Proposed Turkey Point Units 6 and 7
Docket Nos. 52-040 and 52-041
FPL Response to NRC RAI No. 02.05.01-21 (eRAI 6024)
L-2013-236 Attachment 17 Enclosure A Page 1 of 7

SSHAC Level 2 Questionnaire in Support of Cuba Hazard Sensitivity Calculations

NRC RAI Letter No. PTN-RAI-LTR-041

Figure 2 Geologic Maps of Sierra Maestra Region of Cuba
 (Rojas-Agramonte et al. 2005)

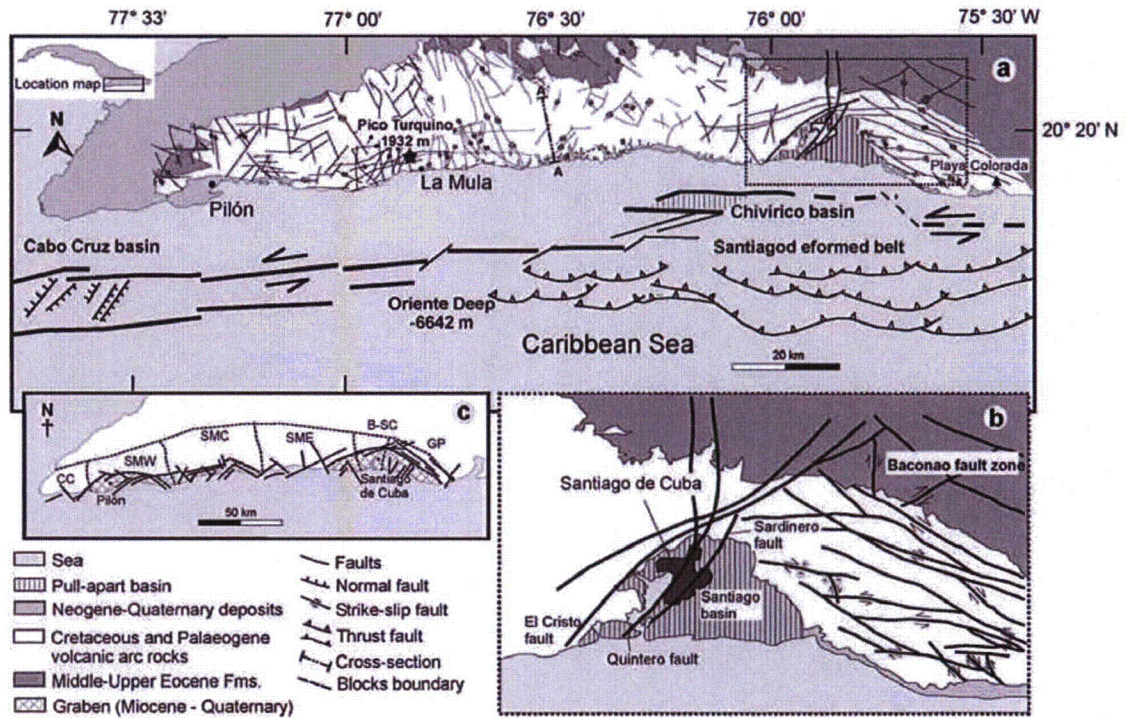
e) Provide map and discussion of the faults associated with the Sierra Maestra. Consider for example Taber (1931) which describes a scarp associated with the Sierra Maestra as "so fresh that its age must be measured in hundreds of years rather than tens of thousands." In addition discuss the relationship of these faults to nearby seismicity.

The Sierra Maestra is an east-west-trending mountain range in southernmost Cuba, located approximately 450 miles (725 kilometers) from the site and adjacent to the offshore Oriente fault. Figure 2 shows a simplified depiction of faults in the Sierra Maestra, based on mapping by Rojas-Agramonte et al. (2005). The Oriente fault and near-shore portion of the Sierra Maestra are an area of abundant ongoing seismicity (Figure 1C) and neotectonic faulting (Oliva Gutierrez 1989, plate IV.3.2-3; Rojas-Agramonte et al. 2005). Taber's (1931, p. 532) observation from the near-shore Sierra Maestra at Puerto Pelado ridge near Santiago de Cuba of a "scarp so fresh its age must be measured in hundreds of years" is consistent with this active tectonic setting.

The scarps in the Sierra Maestra may be related to some of the seismicity in southeastern Cuba. Given the proximity to the modern plate boundary, as well as the abundant moderate- to strong-magnitude seismicity (Figure 1C), there almost certainly are active faults in this region. However, as described in part a), the confident association of specific earthquakes with a given Sierra Maestra fault is problematic due to the uncertainties associated with the locations of both faults and earthquakes in Cuba. For the purposes of characterizing ground-motion hazard at the site, the entire plate boundary rate is modeled on the offshore Oriente fault source and is not represented as a more complex series of diffuse faults along the plate boundary. A thin strip of the near-shore portion of the Sierra Maestra is excluded from the Cuba areal seismic source zone (revised FSAR Figure 2.5.2-217). The seismic moment release from this thin near-shore portion of the Sierra Maestra is assumed to be related to deformation associated with the Oriente fault system and therefore is included in the seismic source model as part of the Orient fault-East seismic source. The remainder of the Sierra Maestra is included in the seismic source characterization as part of the Cuba areal source, and the seismicity observed from this portion of the Sierra Maestra is included in the assessment of seismicity recurrence rate for the entire areal source.

Figure 1A Fault Map of Western Cuba Showing Earthquakes from the Phase 2 Earthquake Catalog.

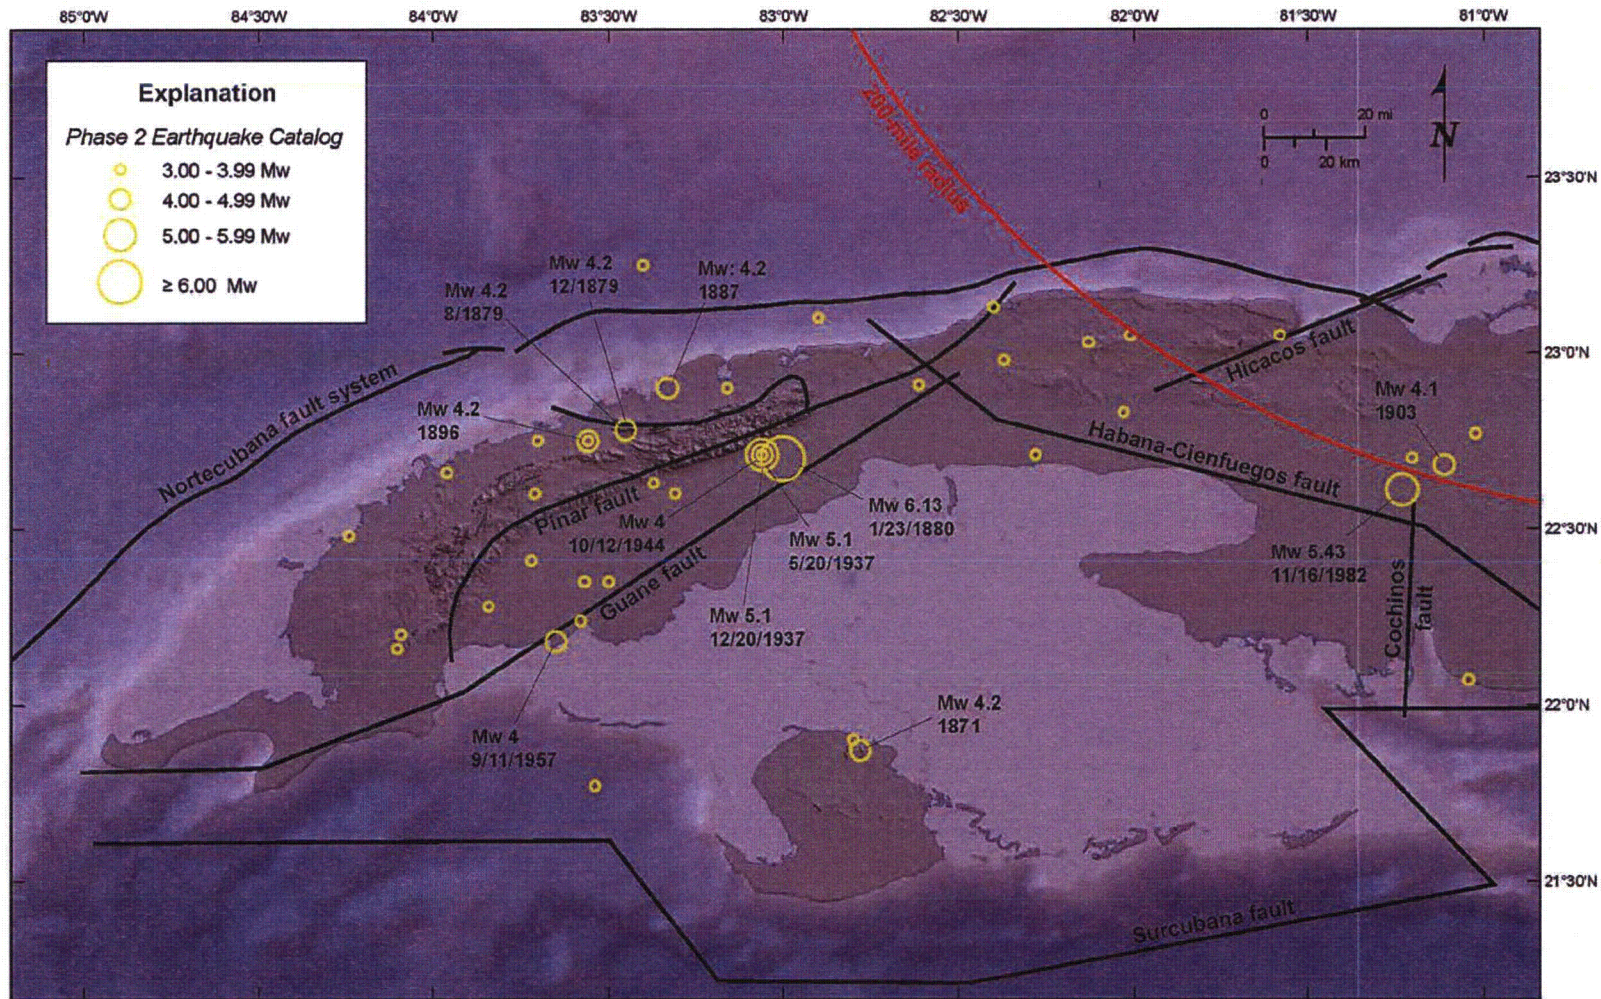
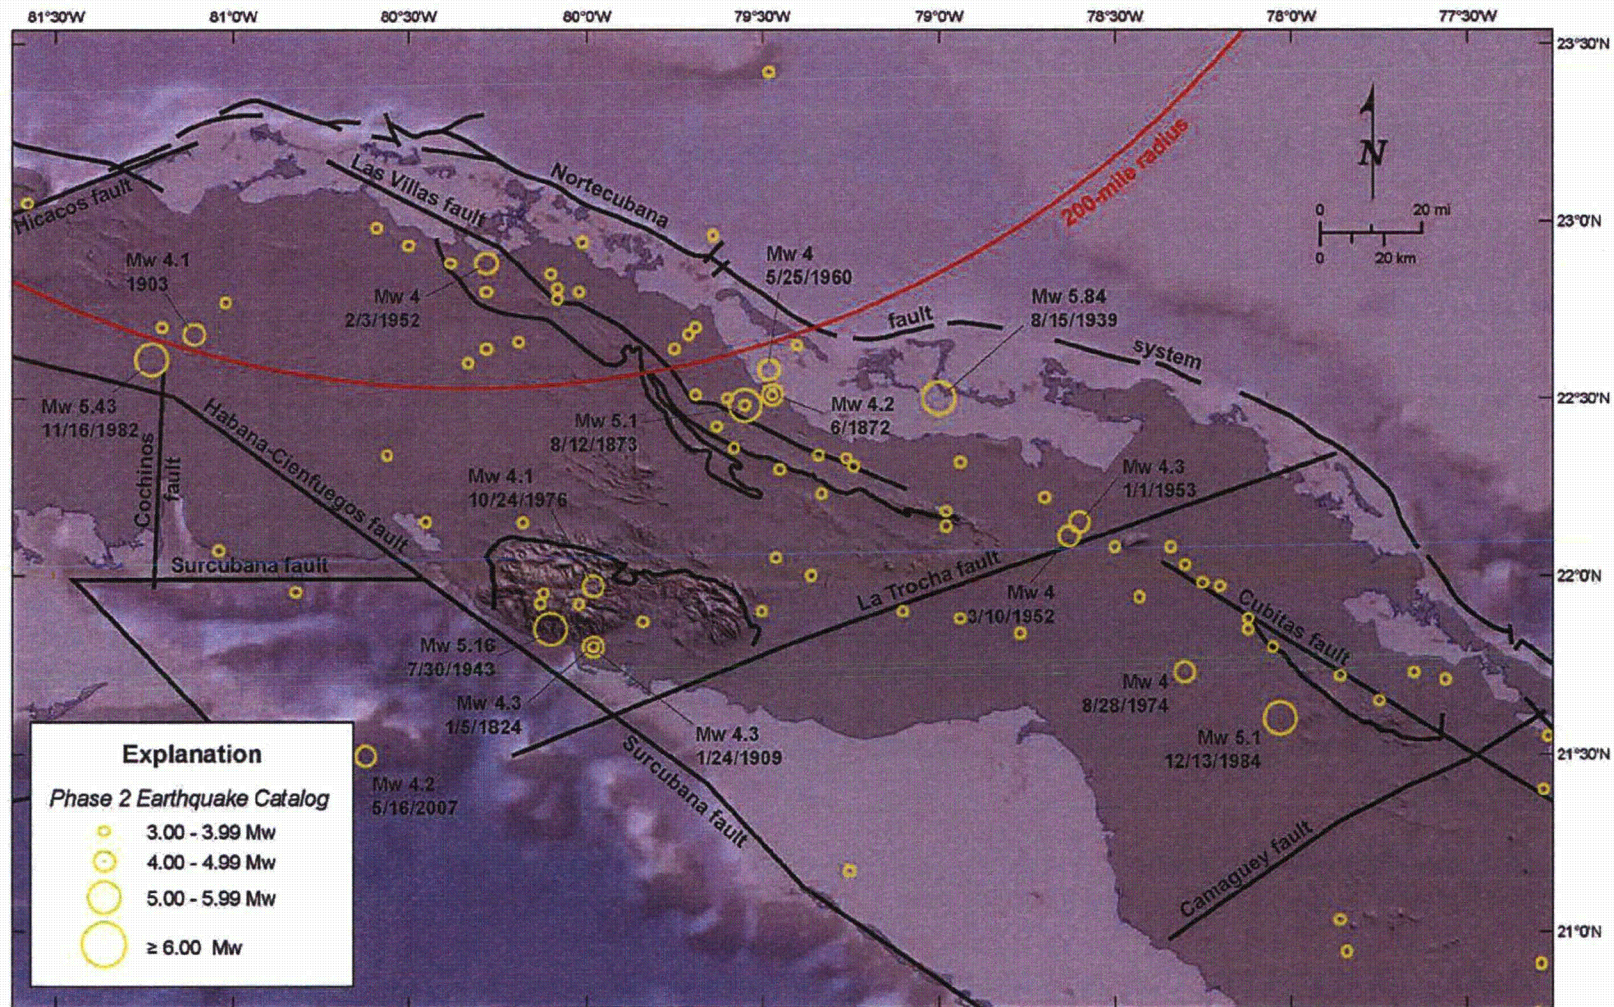
- a) Provide a map of the Cochinos fault with respect to topography and bathymetry, and discuss if the association of the Cochinos fault with bathymetric relief provides geologic evidence for activity.
- b) Map seismicity with respect to the Cochinos fault trace, showing location uncertainties, and discuss the relationship of the fault to seismicity.

Various researchers present different locations and extents for the Cochinos fault. For example, Figures 1A and 1B show the location of the Cochinos fault after Hall et al. (2004) (FSAR Reference 770), who indicate the fault at its nearest point is approximately 205 miles (330 kilometers) from the Turkey Point Units 6 & 7 site. Cotilla-Rodriguez et al. (2007) (FSAR Reference 494) suggest this fault may extend northward to within 175 miles (280 kilometers) of the site, whereas mapping by Mann et al. (1990) (FSAR Reference 493) indicates a closest distance of approximately 210 miles (340 kilometers).

Earthquake location errors are not shown on Figures 1A and 1B because the data with which to estimate these errors for each earthquake are not available. According to Cotilla-Rodríguez et al. (2007) (FSAR 2.5.1 Reference 494, p.518), the "epicenter determination [for earthquakes] in the western, central, and central-eastern [portions of Cuba] have limitations because of scarce or no permanent seismic stations." Regarding the locations of pre-instrumental earthquakes in Cuba, Garcia et al. (2003) (FSAR 2.5.1 Reference 489, p. 2,569) state that, "Taking into account the complexity of the Cuban tectonic environment, the poor knowledge about the kinematic evolution of the principal fault systems, and the uncertainty in the hypocentral location of historical events (uncertainty of 15-20 kilometers or more in the historical coordinates is reasonable), it is impossible to associate earthquakes with individual faults." Therefore, the association of this sparse seismicity with the Cochinos fault or another mapped or unmapped fault in the vicinity is problematic due to the uncertainties associated with the locations of both faults and earthquakes in Cuba.

Figure 2 Geologic Map of Central Cuba Showing the Cochinos Fault (modified after Oliva Gutierrez 1989 plate III.1.2-3)

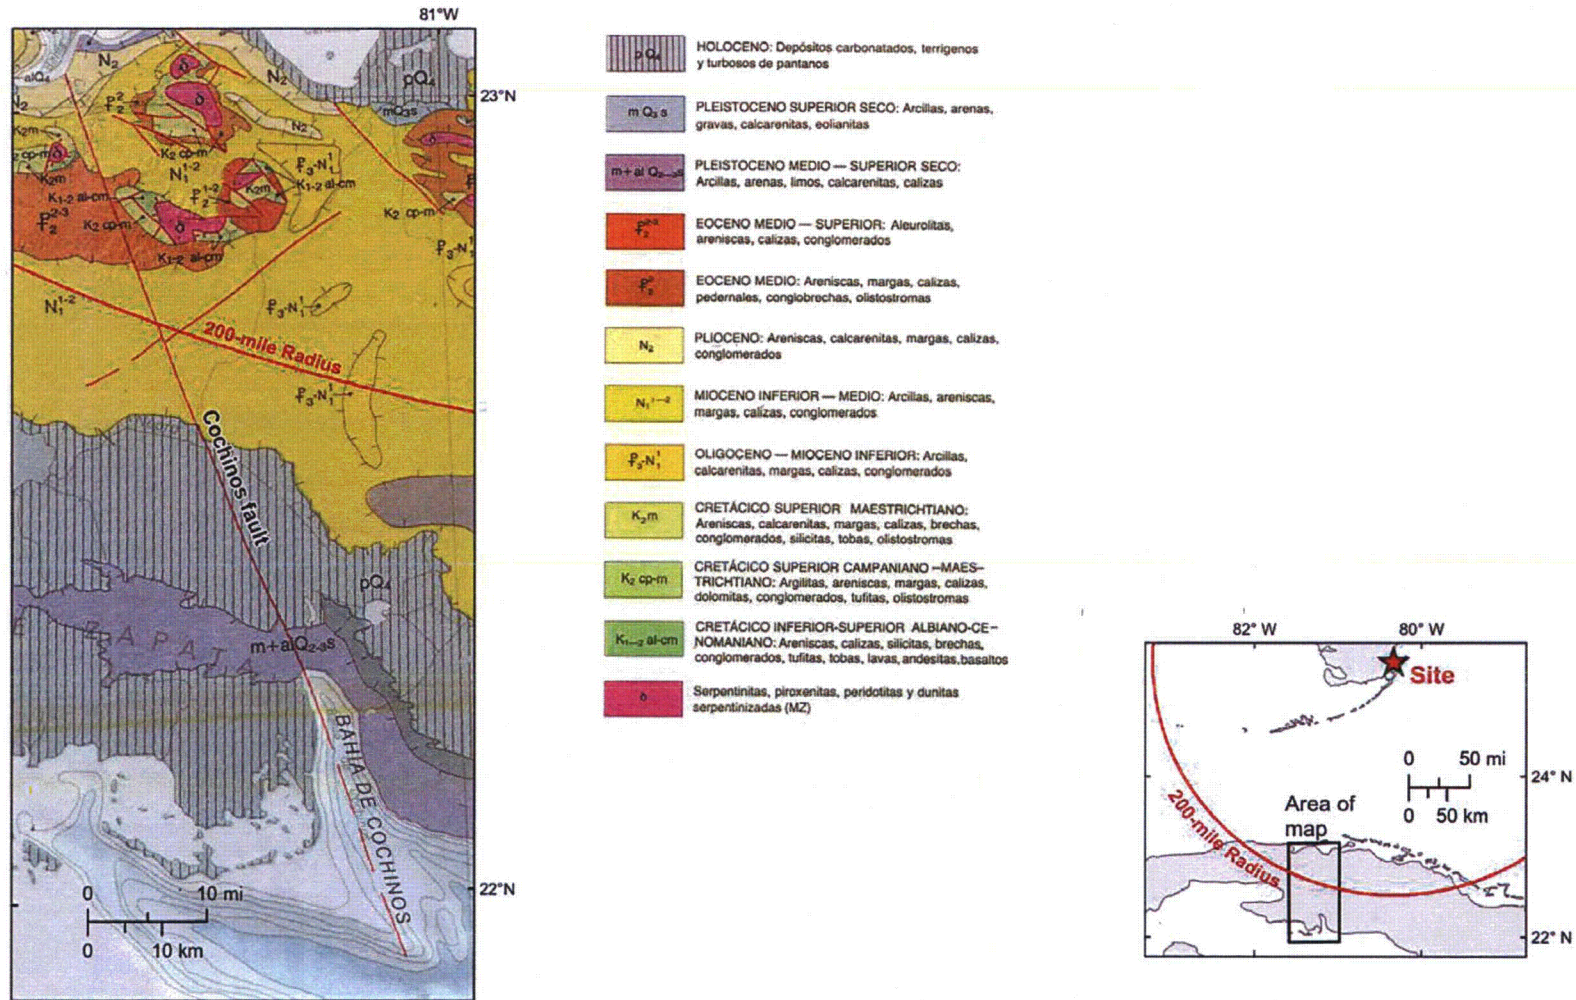
a) Provide a map of the Cochinos fault with respect to topography and bathymetry, and discuss if the association of the Cochinos fault with bathymetric relief provides geologic evidence for activity.

unnamed fault in the vicinity of the Cochinos fault that extends from Cuba's northern coast where it is mapped in Pliocene-age deposits southward into the Bahia de Cochinos (Figure 2). The southernmost 18 miles (30 kilometers) of this fault are shown by a dashed line (Figure 2). At its nearest point, this fault is approximately 185 miles (300 kilometers) from the site. The 1:2,000,000 scale neotectonic map of Cuba from this atlas (Oliva Gutierrez 1989 plate III.2.4-8) shows an approximately 87-mile-long (140-kilometer-long) unnamed fault in the vicinity of the Cochinos fault, the southernmost 30 miles (50 kilometers) of which is offshore southern Cuba and shown by a dashed line. To the north, this fault on the neotectonic map is truncated by the Hicacos fault. The Cochinos fault is depicted and labeled on the 1:2,000,000 scale lineament map from this atlas (Oliva Gutierrez 1989 plate III.3.1-11). On this map, the Cochinos lineament is shown as an approximately 90-mile-long (140-km-long) feature, the southern 25 miles (40 km) of which is located off the southern shore of Cuba and labeled as "supuestos" (assumed or postulated). The 1:1,000,000 scale geomorphic map from the *Nuevo Atlas Nacional de Cuba* (Oliva Gutierrez 1989 plate IV.3.2-3) shows an approximately 37-mile-long (60-kilometer-long) unnamed fault in the vicinity of the Cochinos fault. The map explanation indicates that this fault cuts a Quaternary-age marine abrasion platform that is at an elevation of either 2 – 3 meters or 5 – 7 meters above sea level. They do not provide an explanation for the lack of specificity in elevation of the platform nor do they provide a precise age for the Quaternary abrasion platform.

The southern Cochinos fault is grossly expressed in the topography and bathymetry in the Bahia de Cochinos (Figure 2). The Cochinos fault is the only onshore feature in intraplate Cuba identified as "neotectonic" by Mann et al. (1990) (FSAR Reference 493) (FSAR Figure 2.5.1-286). They map the Cochinos fault as two parallel, north-northwest-striking normal faults that form a graben (FSAR Figure 2.5.1-286). The morphology of Bahia de Cochinos is consistent with this interpretation and suggests the possibility of fault control on the landscape. Cotilla-Rodríguez et al. (2007) (FSAR Reference 494) classify the Cochinos fault as active based on the possible association of seismicity with the fault. Cotilla-Rodríguez et al. (2007) (FSAR Reference 494, p. 514) provide no geologic evidence for activity on the Cochinos fault and describe the fault as "covered by young sediments." Indeed, the most detailed geologic maps inspected in the area (1:250,000 scale) show no fault cutting Miocene and younger strata (Pushcharovskiy et al. 1988) (FSAR Reference 846). It is not clear whether the Cochinos fault is depicted on Perez-Othon and Yarmoliuk's (1985) (FSAR Reference 848) inset map of fault ages in Cuba, but they seemingly indicate a Paleogene age for a northern extension of this fault. Pushcharovskiy's (1989) (FSAR Reference 847) 1:500,000 scale tectonic map of Cuba shows and labels the approximately 60-mile-long (100-kilometer-long) Cochinos fault. This fault does not extend as far north as the Hicacos fault, and the southern approximately 50 miles (80 kilometers) are shown as a dashed line. Garcia et al. (2003) (FSAR Reference 489) provide no discussion of the Cochinos fault.

**Figure 2 Escarpments and Postulated Faults in the Southern Straits of Florida
from Reference 2**

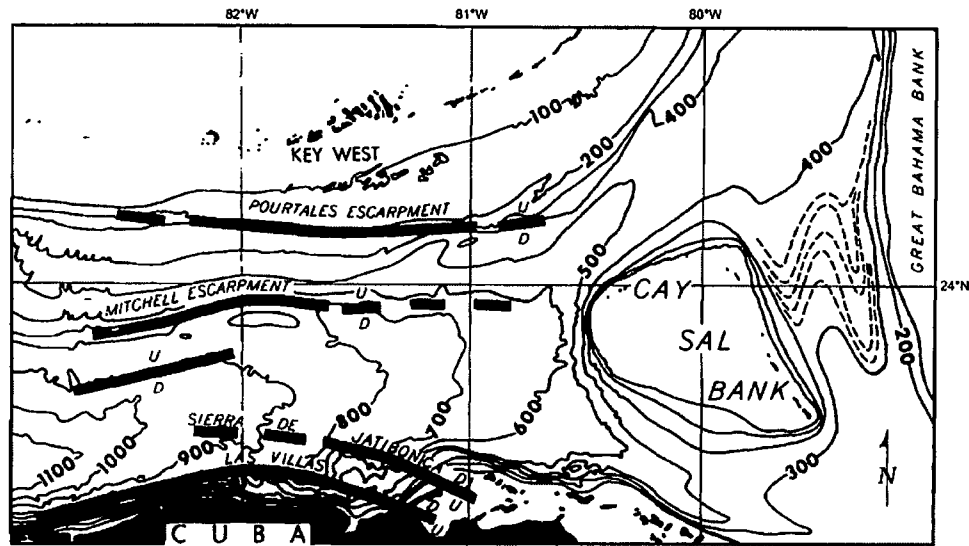
- a) Provide more detail from the Cotilla-Rodríguez et al. (2007) paper regarding the young eroded scarps of the Las Villas fault and specifically address Cotilla's conclusion that the fault is Pliocene-Quaternary in age.
- b) In the context of the chronology of geomorphic surfaces on Cuba, clarify the distinction between erosional processes that may have recently created "young" fault-line scarps along the Las Villas fault and Quaternary tectonic fault scarps.
- c) Discuss bathymetric evidence for the offshore location and recency of faulting along the Las Villas fault.
- d) Address the alignment of epicenters shown on Figure 2.5.1-267 along the Las Villas fault with respect to its tectonic activity. Please plot the uncertainties in event locations and include this information in the discussion.

Reference 2 presents compiled bathymetric and seismic reflection data for the Straits of Florida. They identify escarpments in the Straits of Florida and postulate the existence of faults, including the offshore Las Villas fault (Figure 2). Reference 2 indicates that “since traverses could not be made within 12 [nautical miles] of Cuba, no seismic reflection profiles were obtained of these steep and complex slopes.” As such, they base their offshore mapping of the Las Villas fault on Khudoley’s previous mapping and on their compiled bathymetric data. The depiction in Reference 2 of the offshore Las Villas fault extends for approximately 120 miles (200 kilometers) from roughly Matanzas Bay westward to Havana. Reference 2 states that “the Las Villas fault appears to be reflected in the bathymetry as a scarp”, but they do not provide any description of scarp dimensions, including length, height, and continuity.

Figure 3 Fault Map of Central Cuba Showing Earthquakes from the Phase 2 Earthquake Catalog

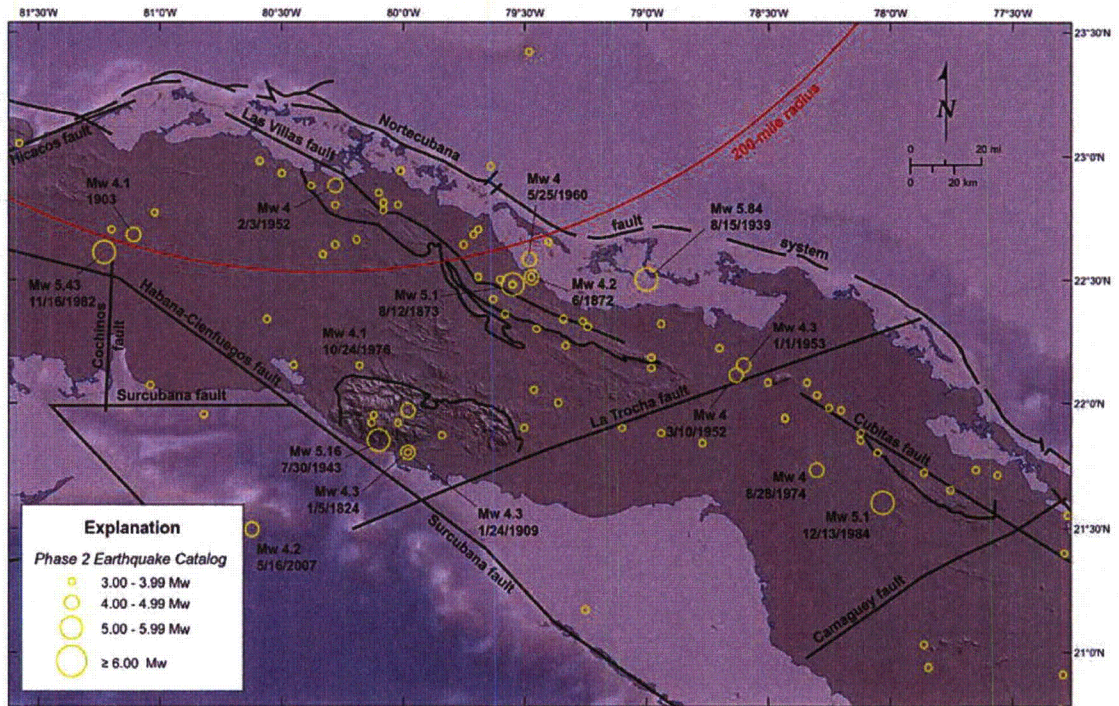
d) Address the alignment of epicenters shown on Figure 2.5.1-267 along the Las Villas fault with respect to its tectonic activity. Please plot the uncertainties in event locations and include this information in the discussion.

At a larger scale, Figure 3 shows moderately sparse seismicity from the Phase 2 earthquake catalog (shown on FSAR Figure 2.5.1-267) that may be roughly aligned with Pardo et al.'s (FSAR Subsection 2.5.1, Reference 439) depiction of the Las Villas fault. The Phase 2 catalog is declustered and includes earthquakes of M_w 3 and above. These earthquakes include both instrumentally located earthquakes and pre-instrumental earthquakes whose locations are based on historical felt intensity reports. The accuracy of the instrument-derived earthquake locations is limited by the lack of permanent seismic recording stations in Cuba, especially for lower-magnitude earthquakes. In fact, many of the earthquake magnitudes and locations from the instrumental era are intensity-based as well, and therefore, the uncertainties in locations of Cuban earthquakes are both high and variable. The accuracy of intensity-based locations is a function of the number and reliability of felt reports, the population density and distribution, and other factors. Even for earthquakes with well-constrained intensity centers, there remains ambiguity in the location of the epicenter because of possible seismic wave directivity effects and other seismologic

A total of 33 earthquakes from the Phase 2 earthquake catalog are located within approximately 6 miles (10 kilometers) of the Las Villas fault along its length. Of these, 29 are located northeast of the trace of this southwest-dipping fault, with the remaining four located southwest of the fault trace. The largest earthquake near the Las Villas fault is the August 12, 1873 M_w 5.1 earthquake, located approximately 3 miles (5 kilometers) northeast of the fault (Figure 3). Cotilla-Rodriguez et al. (FSAR Subsection 2.5.1, Reference 494) indicate focal mechanisms for these earthquakes are unavailable, so it is not possible to assess whether these possibly roughly aligned epicenters occurred on the Las Villas fault or on another fault or faults.
